Inland Transport Committee

Working Party on the Transport of Perishable Foodstuffs

Report of the Working Party on the Transport of Perishable Foodstuffs on its seventy-sixth session

held in Geneva from 13-16 October 2020

“ **Model No. 14**

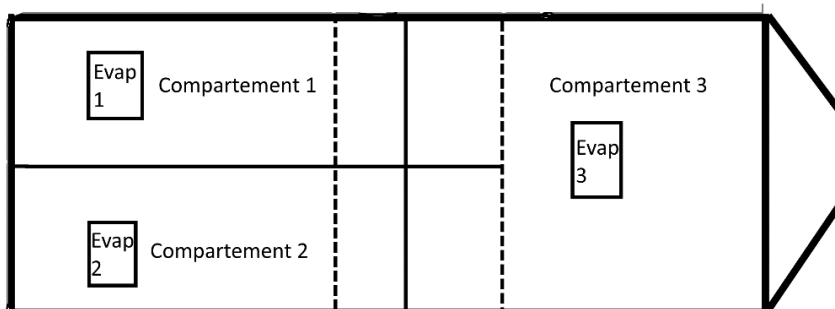
Declaration of conformity for Multi Temperature – Multi compartment equipment

Supplementary document to the Certificate of Compliance as per Annex 1, appendix 2 paragraph 7.3.6

Case 1 – insulation box to be classified as IR:

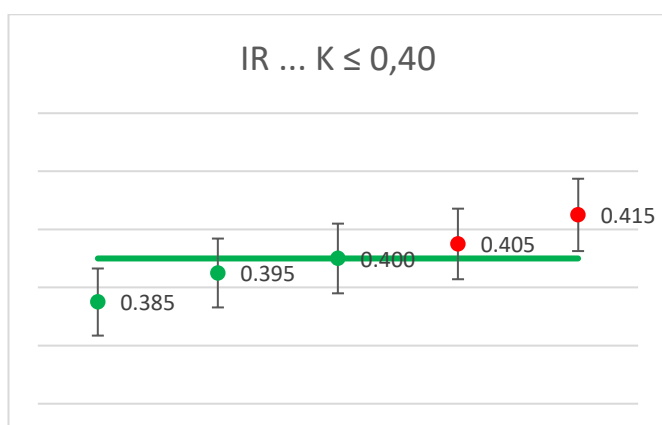
All results for K factor which are smaller or equal to 0,40 conform with IR class (green points). All results for K factor which are greater than 0,40 do not conform with IR class (red points).

Case 2 – insulation box to be classified as IN:

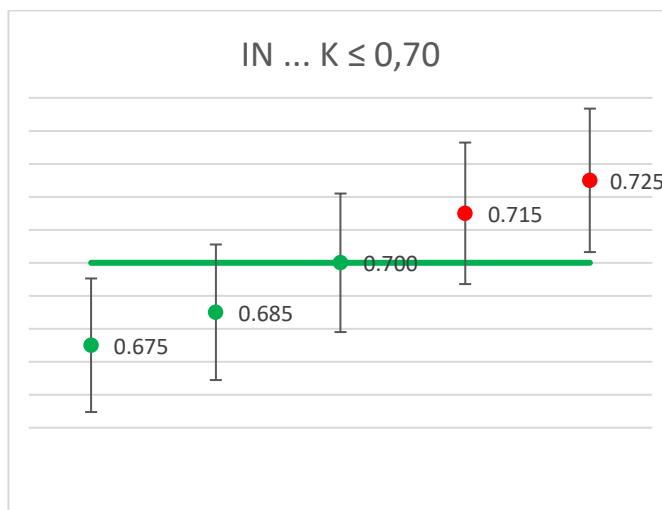
All results for K factor which are smaller or equal to 0,70 conform with IN class (green points). All results for K factor which are greater than 0,70 do not conform with IN class (red points).
